NCHRP Project 22-28, FY 2011

Criteria for Restoration of Longitudinal Barriers, Phase II Comments on the June 2014 Quarterly Report

Upstream End Terminal

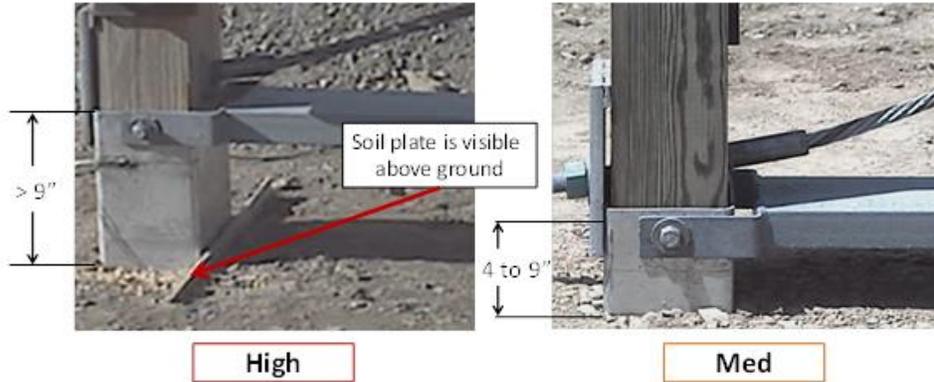
2. Along the same lines, the “other” category in Table 2 might be a bit specific. I certainly appreciate it from a research standpoint but unless the maintenance person had a reasonable high level of expertise, I’m not sure it would help them.

Regarding the information in the “Other” category in Table 2 – We agree that the criteria is a bit specific, but we think it is useful to include these in the field guide in the format shown below (see last two criteria). The maintenance person would simply leave the box “unchecked” if the information is unknown.
